**BELL BEND NUCLEAR POWER PLANT
ENVIRONMENTAL AUDIT NEED FOR
INFORMATION RESPONSES:
FIRST SUBMITTAL
BNP-2012-131 Docket No. 52-039**

The purpose of this letter is to formally document PPL's responses to NRC Need for Information (NFI) requests that were accepted by the NRC at the Bell Bend Supplemental Environmental Audit held the week of May 14, 2012. Additional letters providing the remainder of NFI responses requested by NRC at the audit will be provided in coming weeks.

Figure 1. Average annual river temperatures from the Susquehanna River, 1974-2010. The trend line is the result of a simple linear regression ($P < 0.05$).

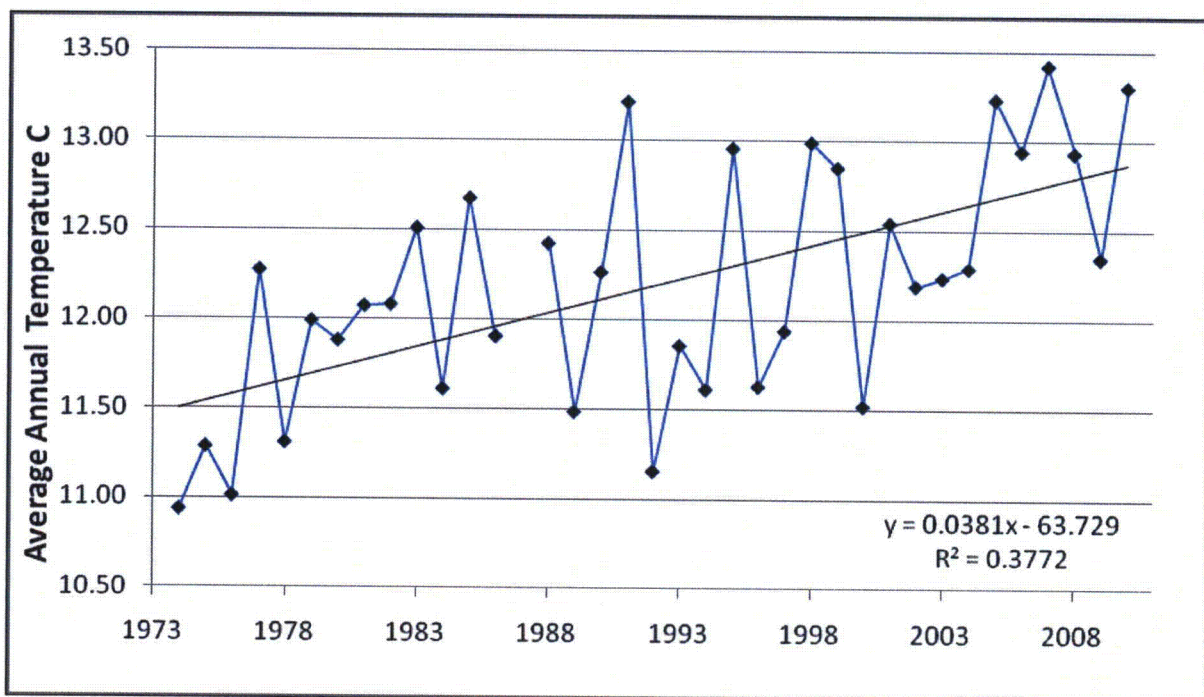
AE-02: Provide an SME to discuss recent (since 1976) water temperature trends in the Susquehanna River and winter conditions including frequency and extent of ice. (Figure 2.3-10 provides coarse scale information).

Data collected from 1974 to 2010 describe an increasing trend in average annual water temperatures as shown on Figure 1, below.

Ecology III, Inc. 1995, page 56.

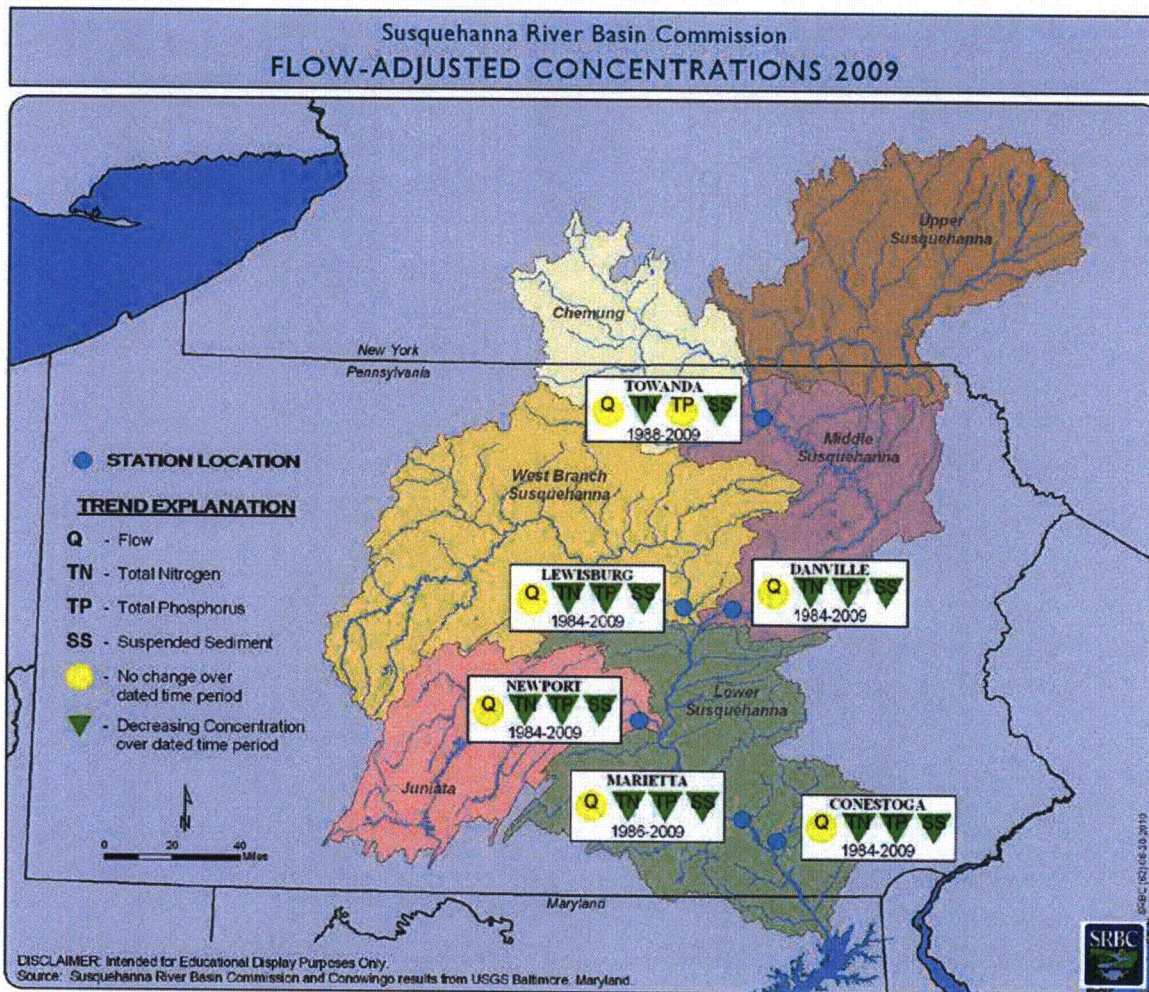
NRHH-05: Provide a knowledgeable expert to discuss historical and any recent algal blooms in local water bodies in the vicinity of the site.

Response: Based on conversations with Dr. Brian Mangan of Kings College, Wilkes-Barre, PA (April 2012) there is no anecdotal or documented information on any historical or recent algal blooms in local water bodies in the vicinity of the site, including Walker Run and its tributaries, Lake Took-A-While, or the Susquehanna River.

The only relevant data known to be available are from studies by Ichthyological Associates/Ecology III from 1977 to 1994 on the Susquehanna River in the vicinity of the site (Ecology III, Inc. 1995). Phytoplankton data (free-floating microalgae generally responsible for algal "blooms") from these studies is provided below. Please note that sample location Bell Bend and Bell Bend I represent algae collection sites, named based on the river location, and are not intended as a specific reference to the current project location.
